**Re: In the Matter of the Application of AEP Ohio Transmission Company, Inc. for Amendment to the Certificate of Environmental Compatibility and Public Need for the Barnesville-Summerfield 138 kV Transmission Line Rebuild Project
Case No. 19-1068-EL-BTA**

AMENDMENT CHANGE SUMMARY

Exhibit 13: Shift 5

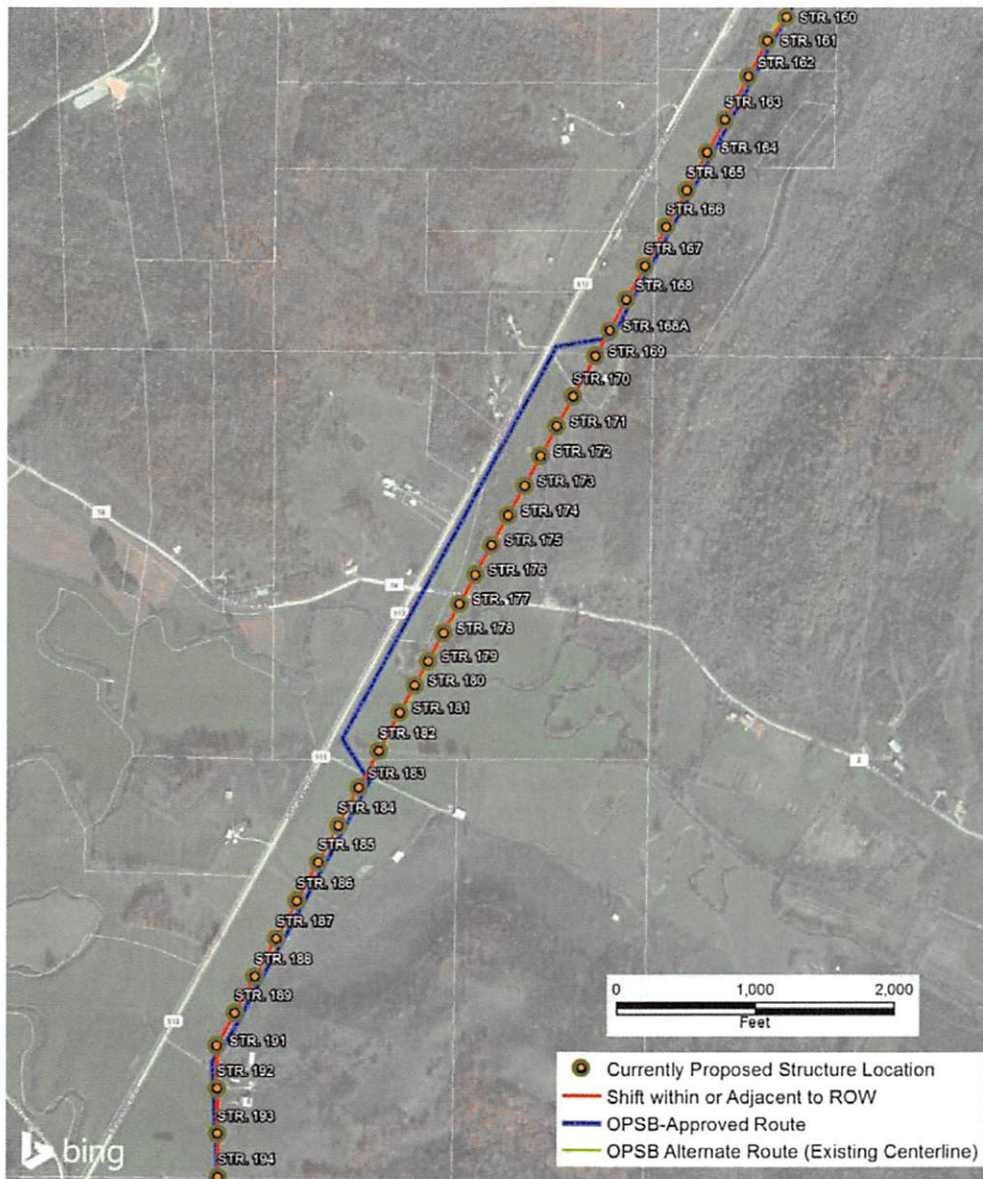
Shift 5 moves the route to the existing centerline between Structures 160 and 194. This shift within the existing ROW did not add any additional parcels or landowners. The shift results in the centerline crossing approximately 200 additional feet of Ohio Rapid Assessment Method (ORAM) Category 1 emergent wetland. However, no disturbance is proposed within the wetland. The centerline was shifted due to the property owner's request. Due to the ability reduce the number of turns and move the proposed centerline further from adjacent residential properties, AEP Ohio Transco decided to shift back to the existing centerline. No additional environmental (including tree clearing) or landowner impacts are expected due to Shift 5.

Exhibit 14: Reroute 1

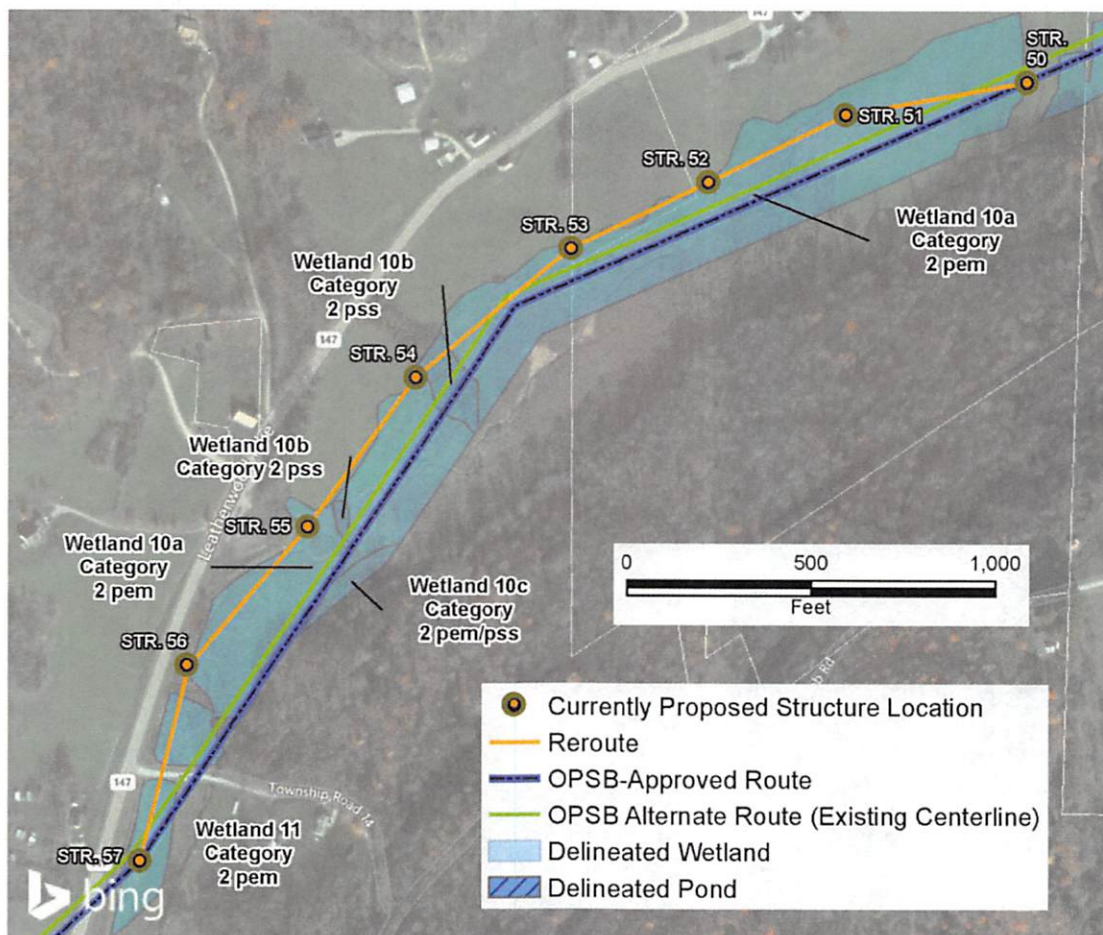
One reroute of the OPSB-approved route between Structures 50 and 57 was necessary to reduce wetland impacts while continuing to accommodate property owners. AEP Ohio Transco negotiated the placement of the centerline at the edge of the wetland with most poles placed in upland areas. The centerline was shifted to decrease the amount of disturbance to the wetlands. Wetlands 10a, 10b, and 10c are an ORAM Category 2 complex with palustrine emergent (PEM) and palustrine scrub/shrub (PSS) components. Wetland 11 is classified as ORAM Category 2, PEM. No additional environmental (including tree clearing) or landowner impacts are expected due to Reroute 1.
